SUBJECT: Yuba River Development Project
FERC Project No. 2246-058 - California
Response to Comments on Updated Study Report and
Updated Study Report Meeting Summary

Responses to Comments on Updated Study Report and Updated Study Report Meeting Summary

Yuba River Development Project FERC Project No. 2246

Figure 2.1.4-1. Flow and detections at Camptonville Diversion Tunnel. Note that maximum diversion capacity is 1,100 cfs.

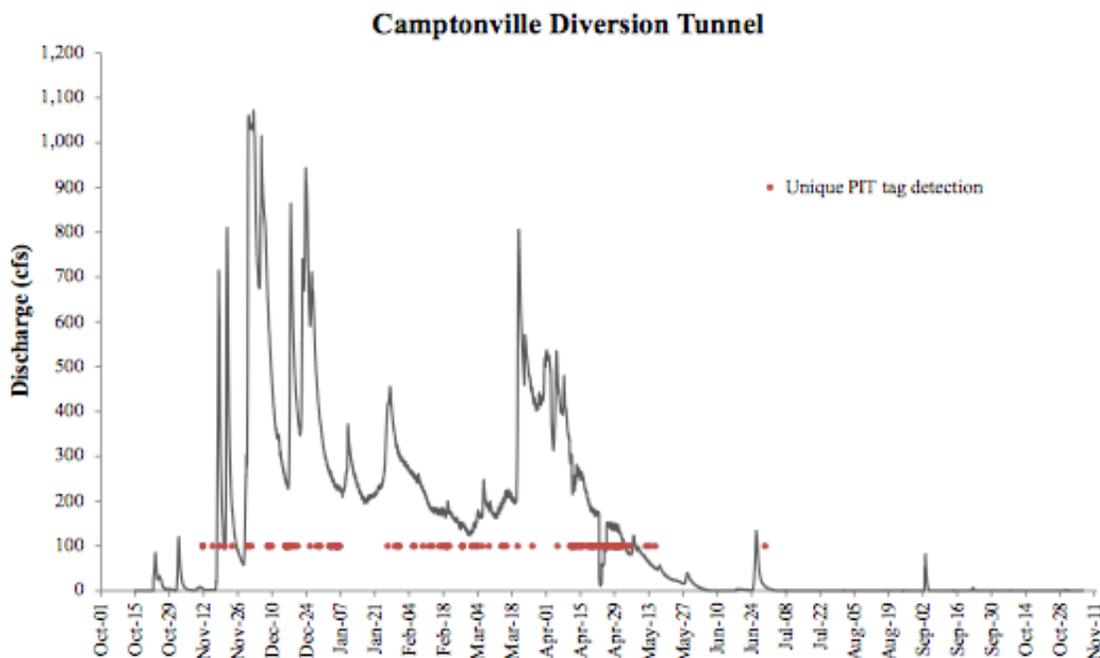
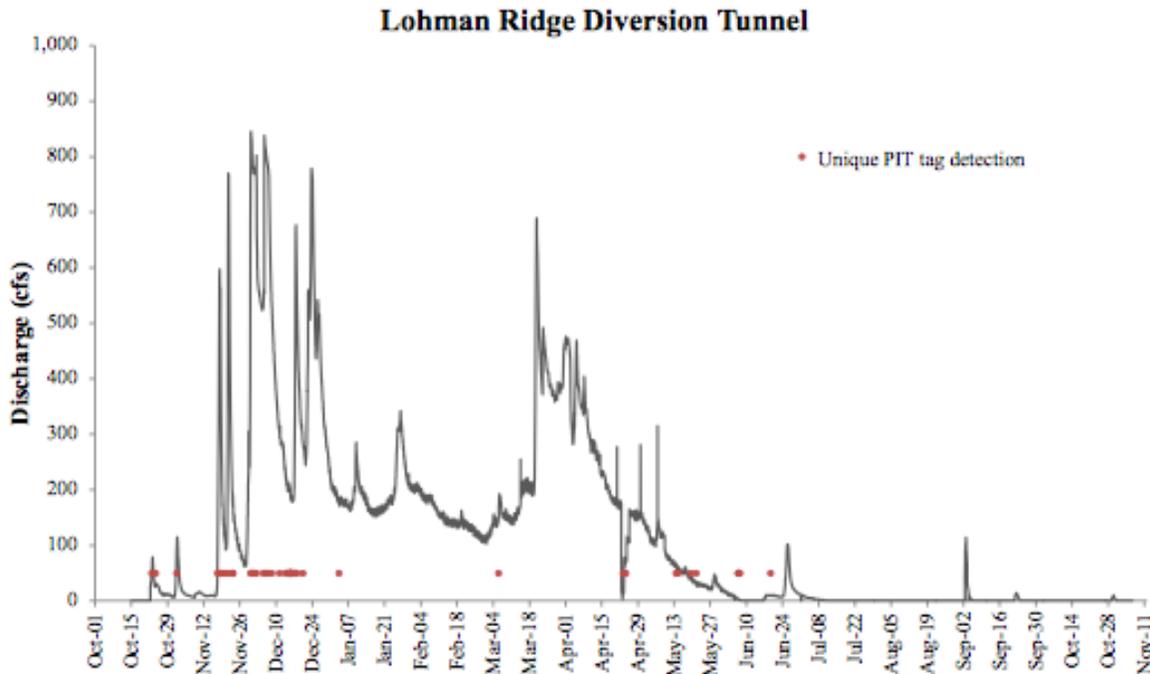
The Forest Service contends that the YCWA did not perform the study in conformance with the FERC-approved study plan. Specifically, the Forest Service states:

Cal Fish and Wildlife suggests that the 2012 and 2013 monitoring years were unrepresentative due to the water year type. For clarity, 2012 was below normal and 2013 was a dry water year. During these periods, the study monitored flows that exceeded 1,000 cfs and were representative of a full range of diversion rates. Figures 2.1.4-1 and 2.1.4-2 show flow and detection at Camptonville (capacity 1,100 cfs) and Lohman Ridge (capacity 860 cfs) tunnels. Both tunnels reach maximum diversion capacity during the monitoring year. Further, a series of studies were conducted that were all flow-dependent and considered representative of Project conditions.

The operation of a diversion facility requires regular maintenance to provide for safe operations. Debris removal is common at any intake. In order to monitor in this environment with flows that exceeded 1,000 cfs, YCWA built a very large half-duplex PIT antenna. To ensure reliable long term operation, some maintenance was required. Periods of maintenance or unmonitored events represented only 0.3 percent and 2.0 percent of the entire monitoring period for the Lohman Ridge and Camptonville diversion tunnel arrays, respectfully. Most events were less than an hour in duration and no events exceeded 6 hours. The study approach was approved by FERC and to assume that the array would never be down for cleaning is unrealistic.¹⁸ Relative to the monitoring period that extended for almost one year, the amount of time the arrays were removed for maintenance represents a very minimal proportion of sampling period.

Any concern regarding efficiency or down periods of maintenance could be further alleviated by extrapolating a rate of catch. YCWA identified that catch was less than 0.6 fish per day for both sites combined, so this extrapolation would likely not result in any substantive change in the reported data. The data are available for assessment by Relicensing Participants and is entirely sufficient for development of license requirements. The study has met the goals and objectives of the study.

Figure 2.2.3-1. Conceptual layout of YCWA’s proposed new Flood Control Outlet and areas that would be affected by construction of the outlet. [from Figure 2.2-5 in Exhibit E in YCWA’s December 2, 2013 DLA.]

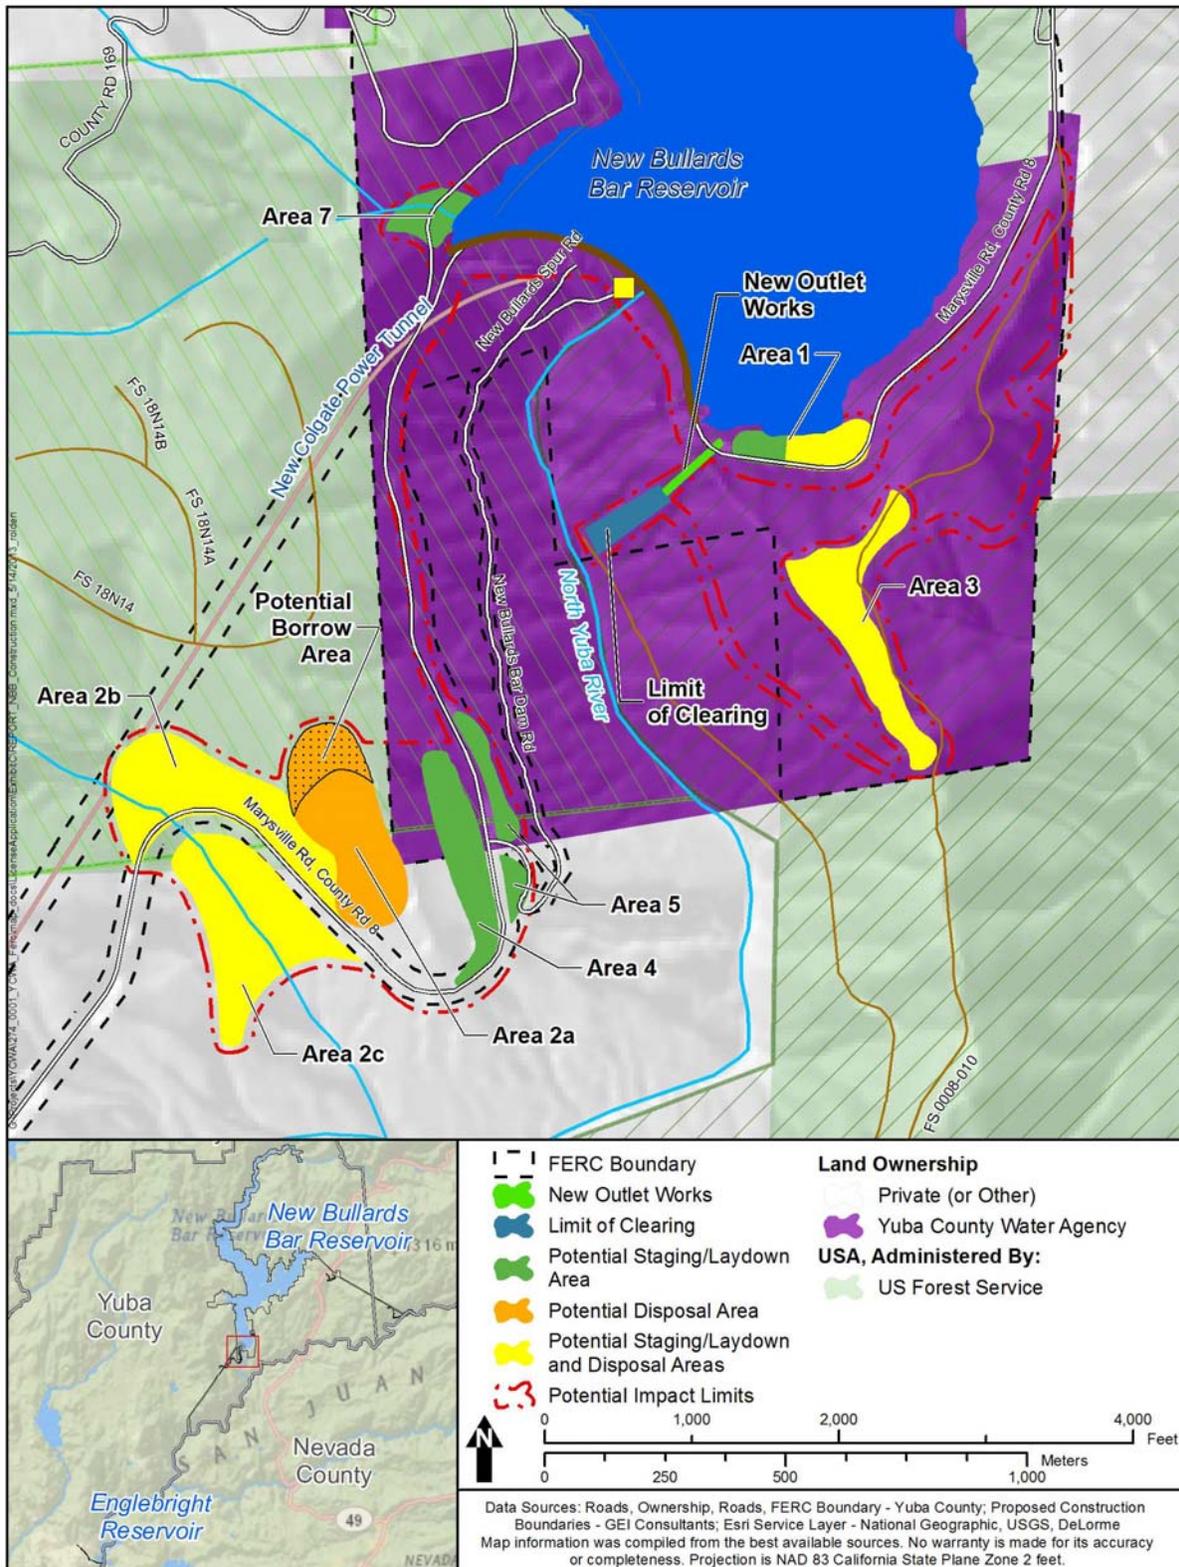
The Forest Service bases its request, in part, on its contention that “*No studies were previously designed to assess effects of construction on NFS lands and provide operational scenarios.*” (Page 9 of Attachment 1 to the Forest Service’s January 30, 2014 letter). Cal Fish and Wildlife bases its request, in part, on its contention that that “*No studies were previously designed to assess effects of construction on fish, wildlife and plant resources, and provide operational scenarios.*” (Page 18 of Cal Fish and Wildlife’s January 30, 2014 letter).

First, YCWA must clarify that, except for small portions of potential borrow areas 2a, 2b and 2c, the proposed new Flood Control Outlet does not affect NFS land. As shown in Figure 2.2.3-1, the entire facility and the area potentially affected by construction are located on YCWA-owned or privately-owned land. Further, there is no NFS land downstream of New Bullards Bar Dam. Therefore, the only areas that directly affect NFS land are those small portions of potential borrow areas 2a, 2b and 2c.

Second, both the Forest Service and Cal Fish and Wildlife incorrectly state that the existing FERC-approved studies do not provide information regarding resources potentially affected by construction, operation and maintenance of the new Flood Control Outlet. Table 2.2.3-1 lists how each of the FERC-approved studies, for which the Forest Service and Cal Fish and Wildlife request “developing targeted surveys and/or mapping efforts,” provide information relevant to the new Flood Control Outlet.
